**RANCHO SECO NUCLEAR GENERATING STATION
UNIT NO. 1**

SUPPLEMENT NO. 2

PRELIMINARY SAFETY ANALYSIS REPORT

Now comes SACRAMENTO MUNICIPAL UTILITY DISTRICT and amends its above numbered application by submitting herewith Supplement No. 2. This supplement reflects a change in the type of tendon used for the reactor containment building post-tensioning system, and in the type of cooling tower used for power conversion cycle heat rejection.

FIGURE 1.1-2
SITE PLAN

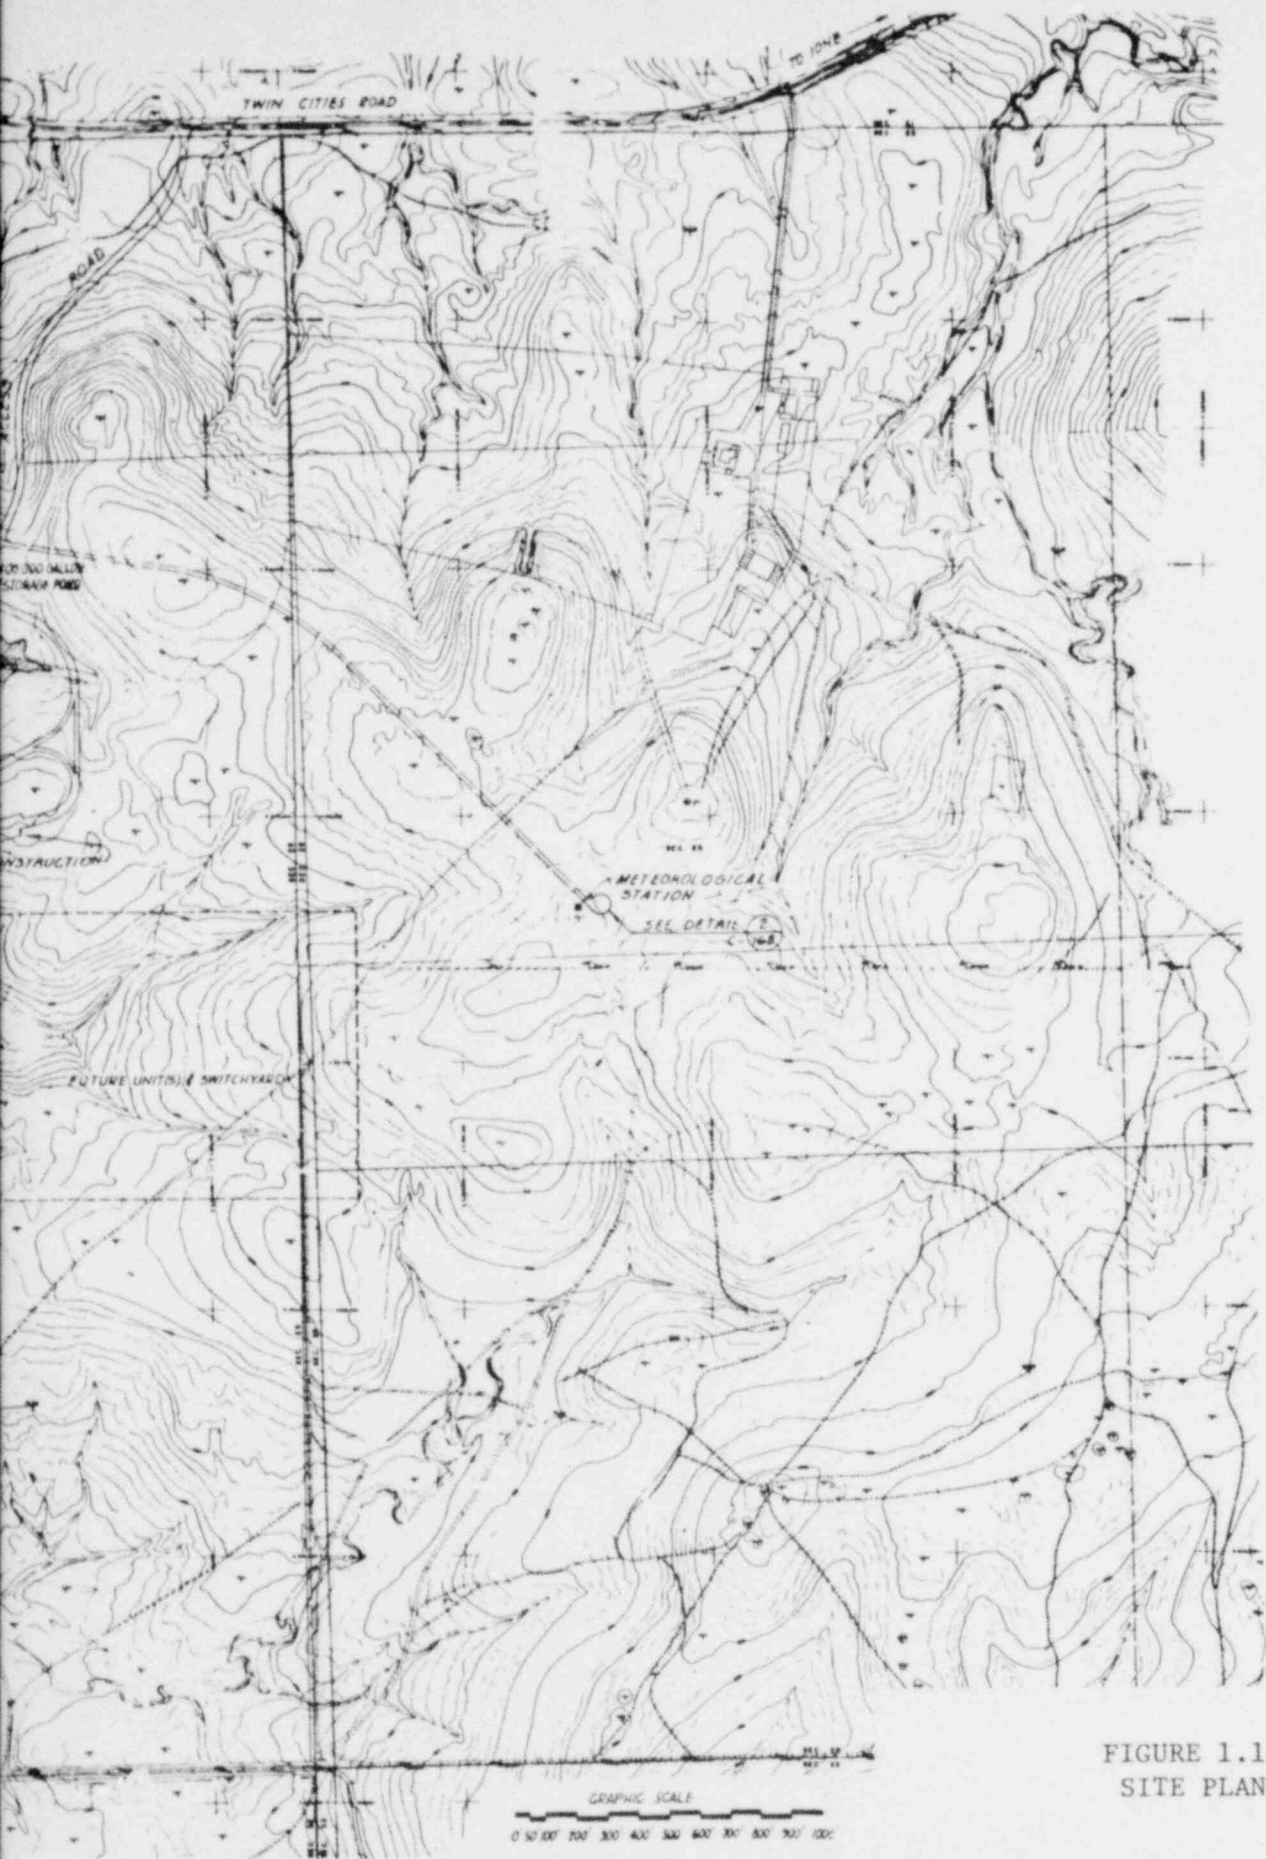
- a) A change in the type of tendon system proposed for the prestressed reactor containment building. An updated Section 5 incorporating the VSL tendon system is included together with a description of the system and SMUD's analysis of it in Appendix 5K. This portion of the supplement answers questions raised in AEC's letter dated February 27, 1969, Item 7 as it pertains to the tendon system.
- b) A change in containment liner plate material to ASTM A285. Opportunity has been taken to present additional data on containment liner anchorages as requested in item 13 of AEC's letter of February 27, 1969.
- c) A change in the type of cooling tower used for heat rejection in the power conversion cycle from mechanical draft to two natural draft hyperbolic towers. These structures, each 425 ft. high and 310 feet base diameter, are shown on Figures 1.1-2 and 1.1-3 attached.

FIGURE 5.1-1
 REACTOR BUILDING
 TYPICAL DETAILS
 SHEET 1

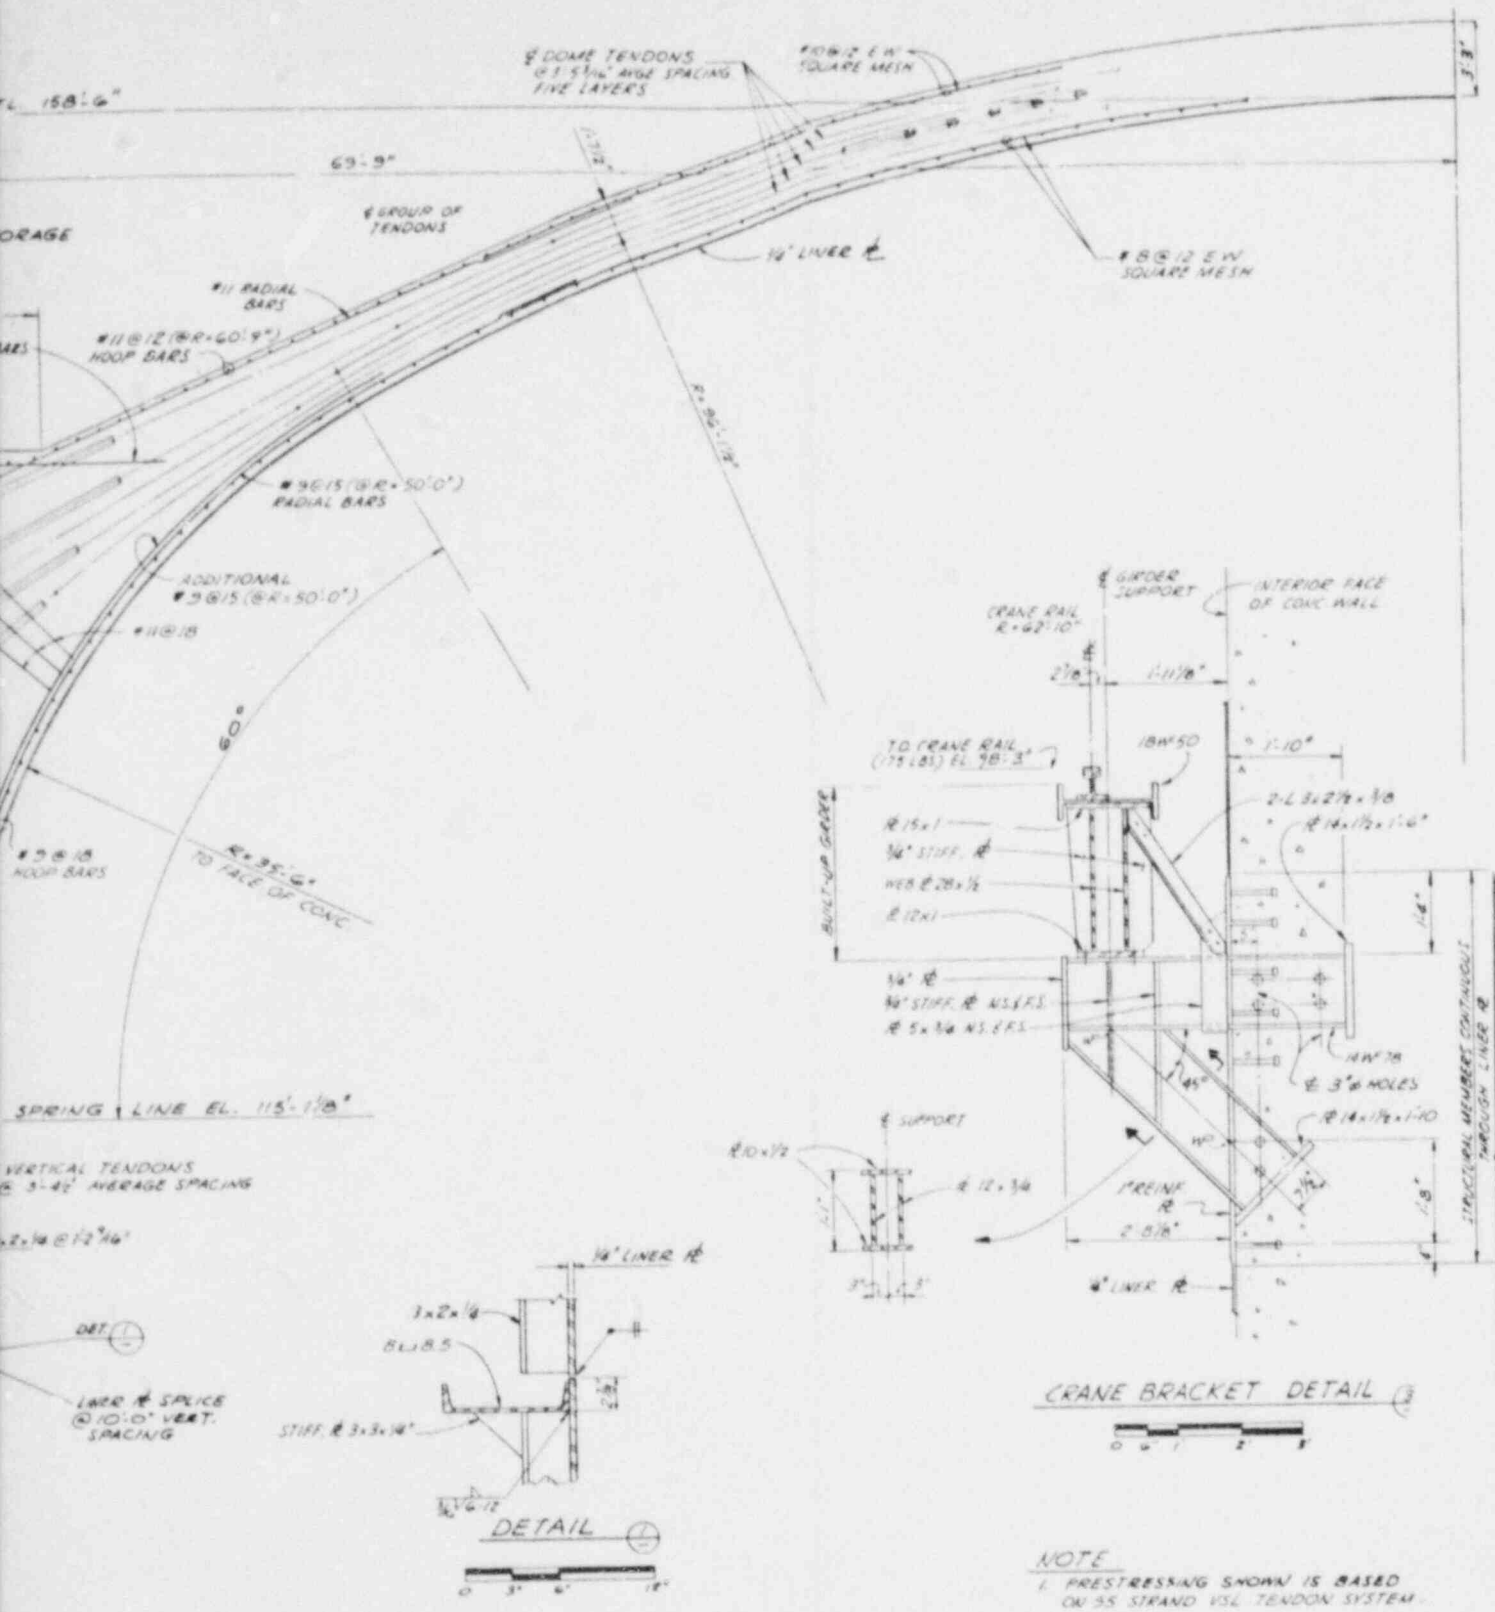
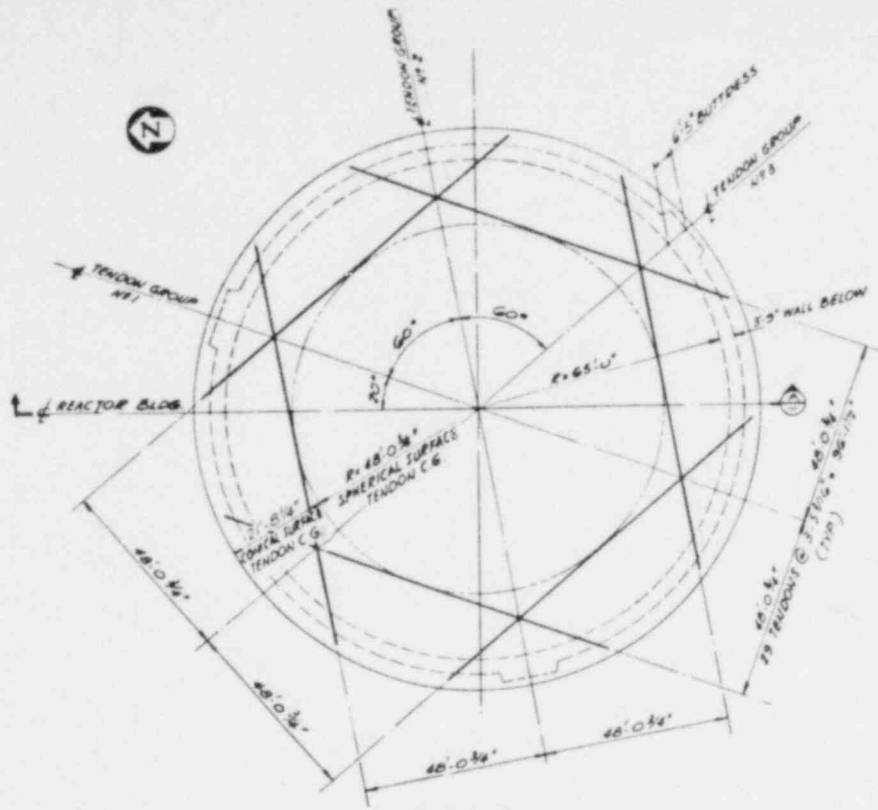
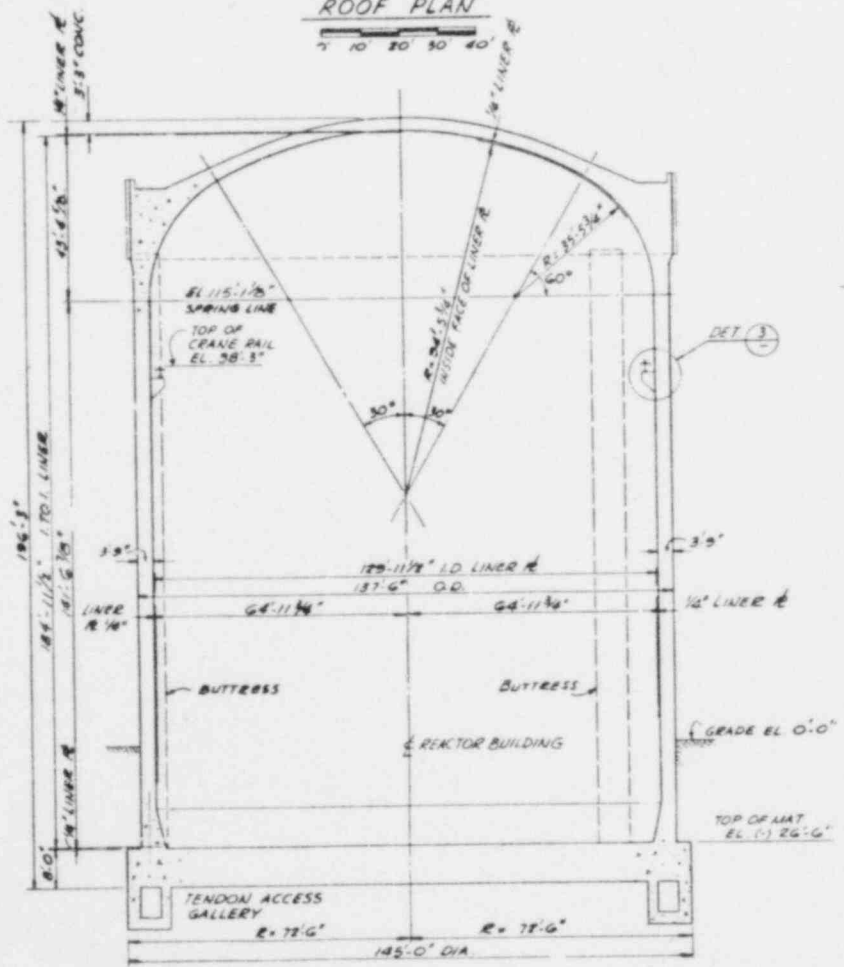
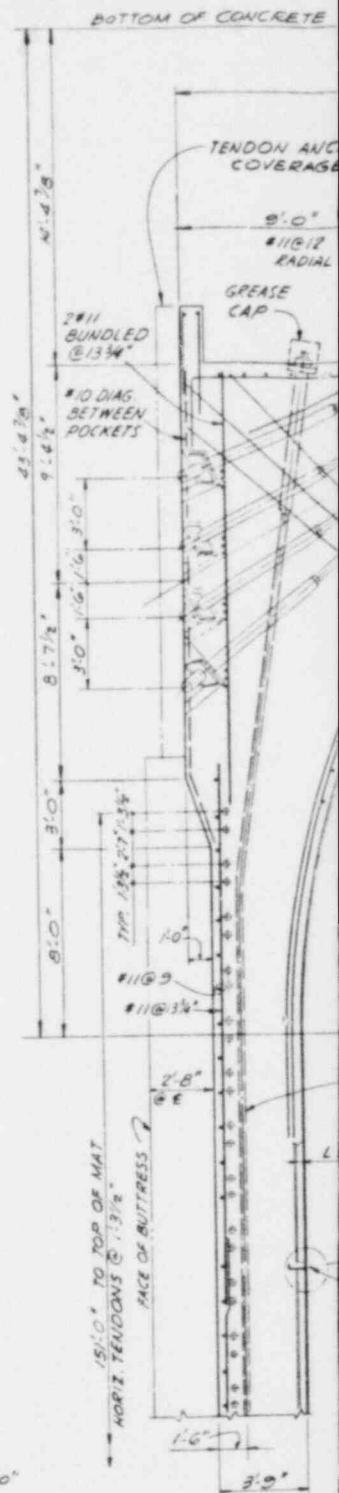
NOTE
 1. PRESTRESSING SHOWN IS BASED ON 55 STRAND VSL TENDON SYSTEM.

FIGURE 5.1-1
REACTOR BUILDING
TYPICAL DETAILS
SHEET 2

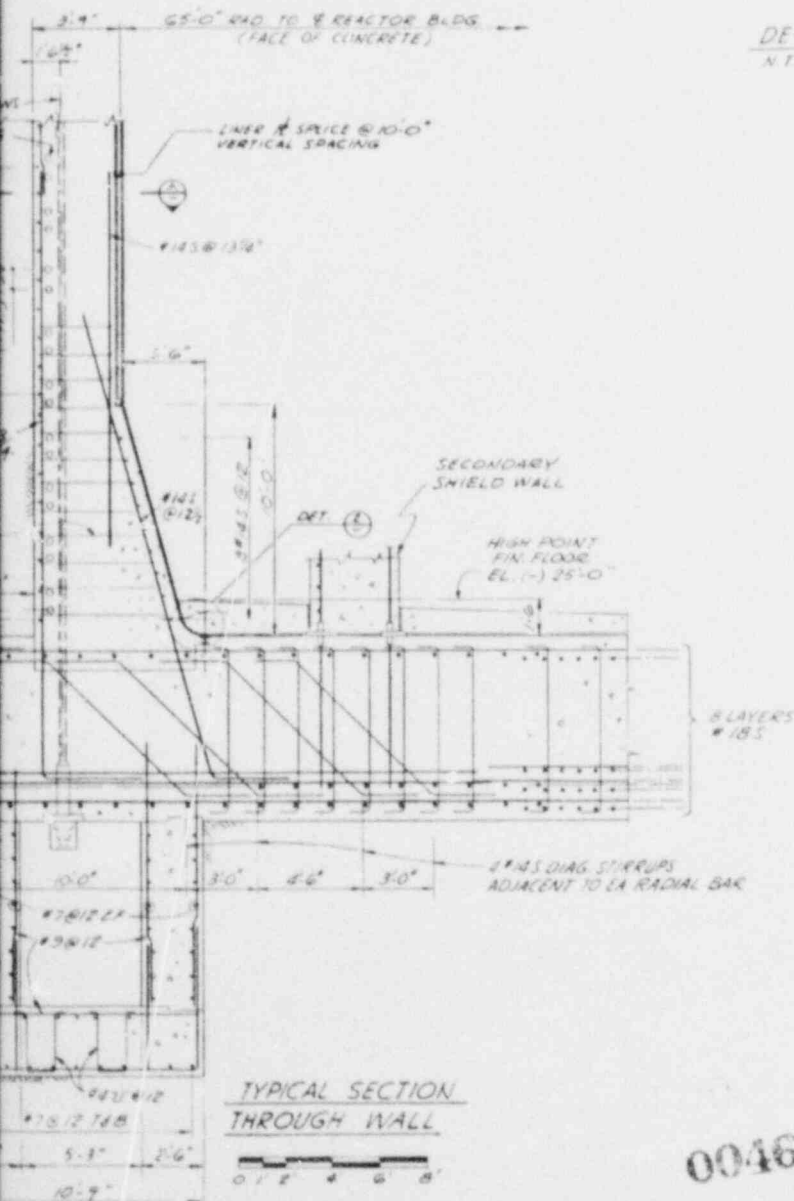
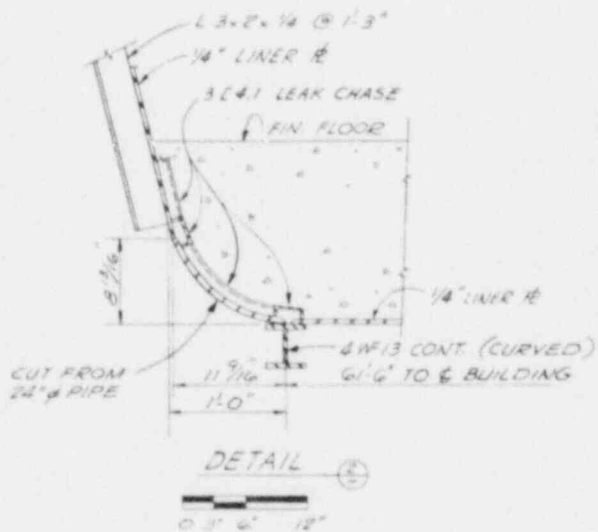
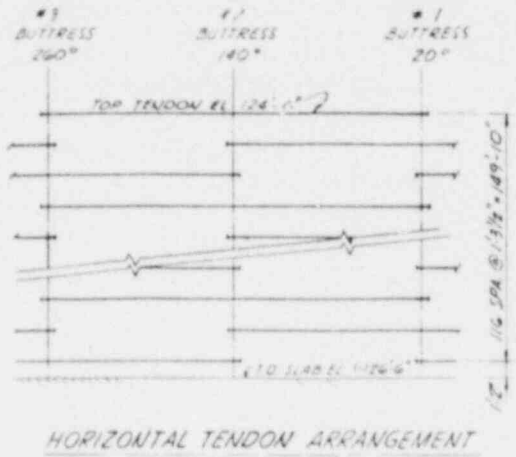
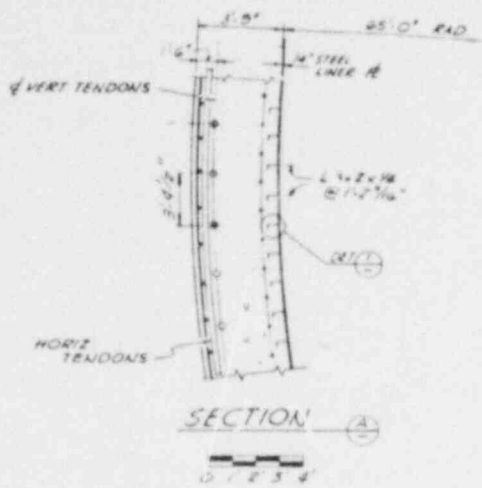
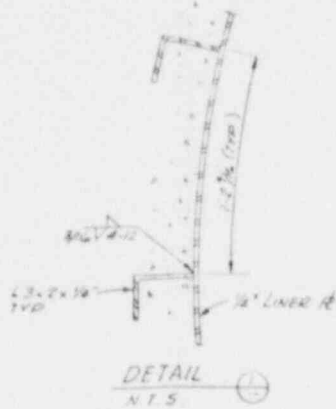
NOTE
PRESTRESSING SHOWN IS BASED ON
35 STRAND VSL TENDON SYSTEM.
